3.0 General Amendments

Proposed Design Changes - South elevation

Proposed Design Changes - West elevation (Guilford Place terraces removed)

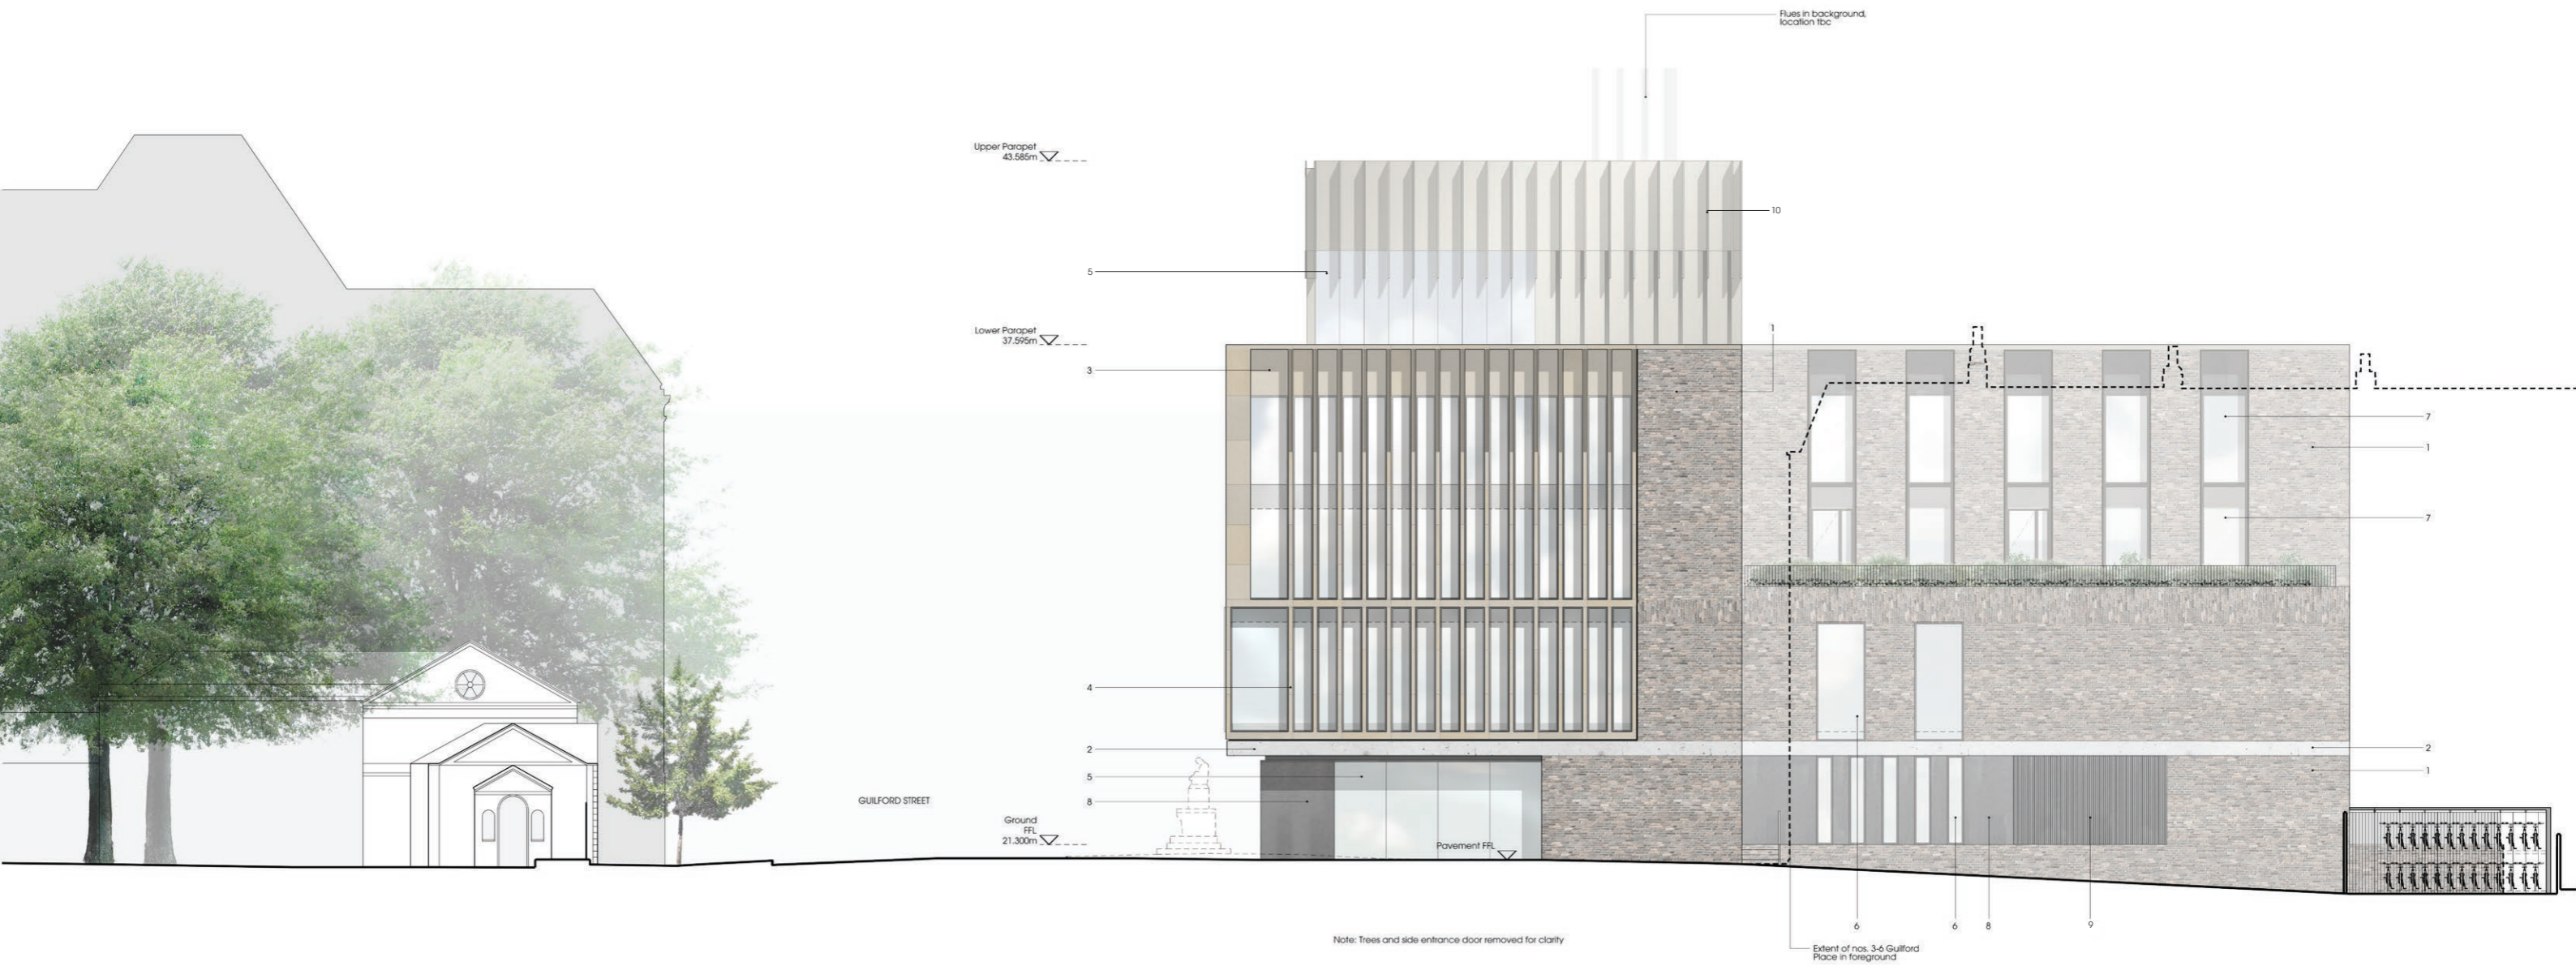
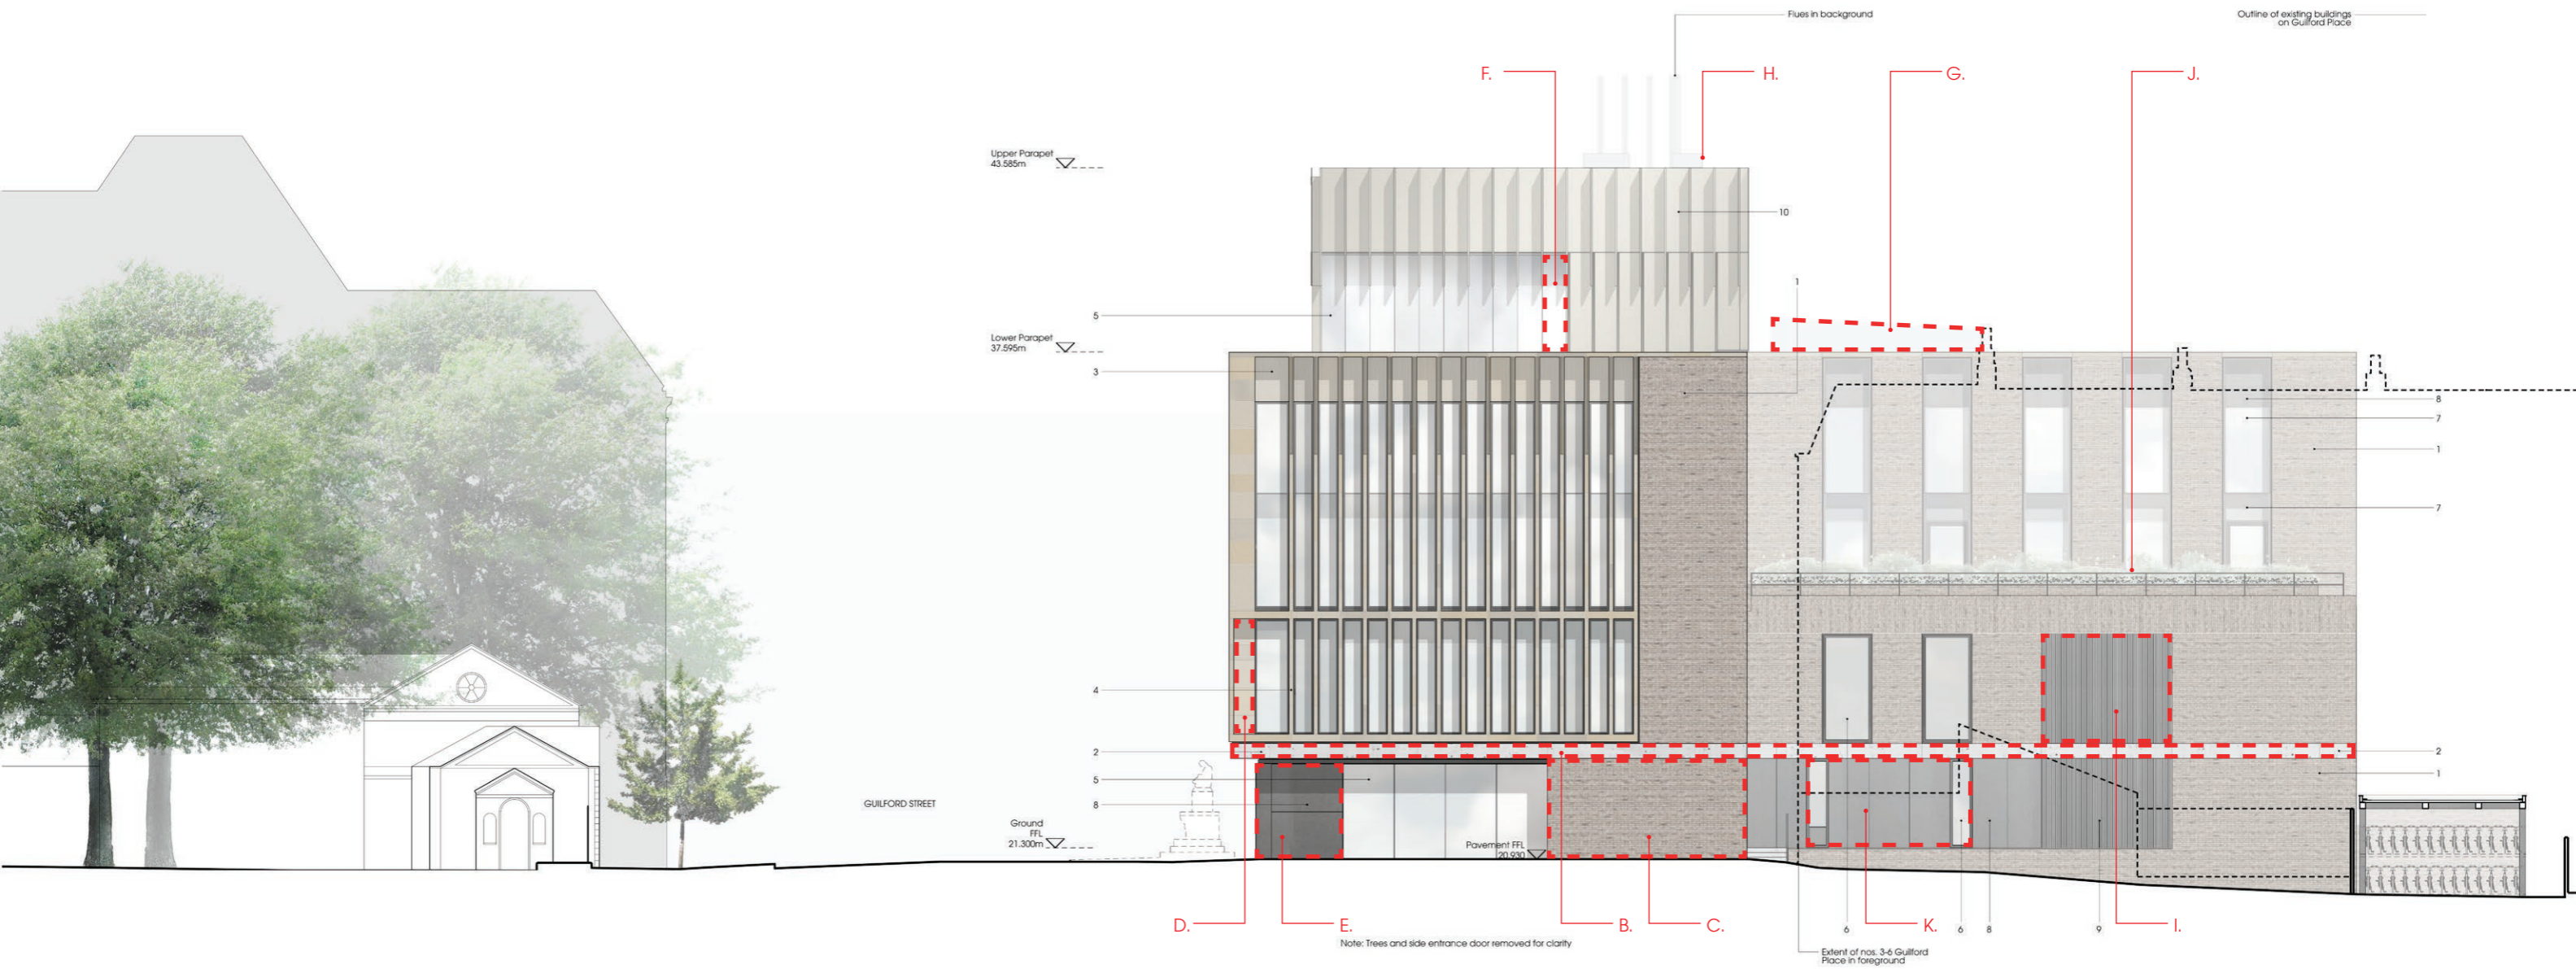
- B. GRC in lieu of precast cladding to first floor fascia
- C. Stretcher bond in lieu of English bond brickwork on ground floor
- D. Terracotta fin corner detail rationalised on first floor
- E. Extent of metal cladding on ground floor increased
- F. Glazing on fourth floor extended to suit internal layout
- G. Main atrium rooflight raised to incorporate smoke extract louvres
- H. Ventilation fans added on roof level
- I. Intake louvres added on the first floor west elevation to suit MEP design
- J. Balustrade to second floor terrace simplified (west elevation only)
- K. 3 windows removed on ground floor
